HORSHAM DISTRICT COUNCIL CONSULTATION

TO:	Horsham District Council – Planning Dept
LOCATION:	Cedar Cottage Sandygate Lane Lower Beeding West Sussex
DESCRIPTION:	Demolition of existing dwelling and erection of 24no. dwellings including the creation of a new access from Sandygate Lane with associated works.
REFERENCE:	DC/26/0640
RECOMMENDATION:	Modification

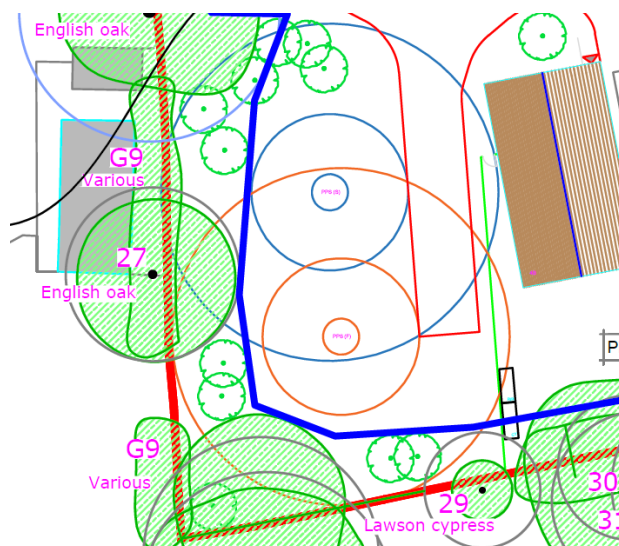
8. Clarification is requested regarding 'PPS (S)' and 'PPS (F)' to the southwest of the scheme, attached below.
